# **NVM Express Technical Errata**

Errata ID	008
Change Date	11/6/2013
Affected Spec Ver.	NVM Express 1.0 and NVM Express 1.1a
Corrected Spec Ver.

The definition of reserved has been refined to clarify cases of value coded fields.

## Modify bytes 23:16 of Figure 12 as shown below:

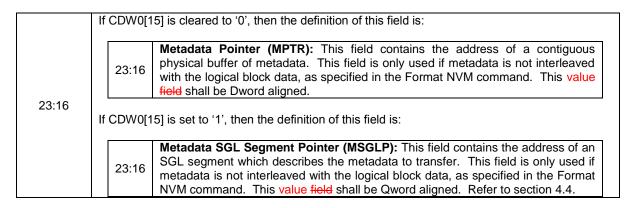
Modify the Metadata (SGL Segment Pointer) definition in Figure 124 (Compare), Figure 137 (Read), and Figure 159 (Write) as shown below:

Bit	Description	
	If CDW0[15] is cleared to '0', then the definition of this field is:	
	63:00 <b>Metadata Pointer (MPTR):</b> This field contains the address of a contiguous physical buffer of metadata, if applicable. This value field shall be Dword aligned.	
63:00	If CDW0[15] is set to '1', then the definition of this field is:	
	Metadata SGL Segment Pointer (MSGLP): This field contains the address of an SGL segment containing exactly one SGL Descriptor that describes the metadata to transfer, if applicable.
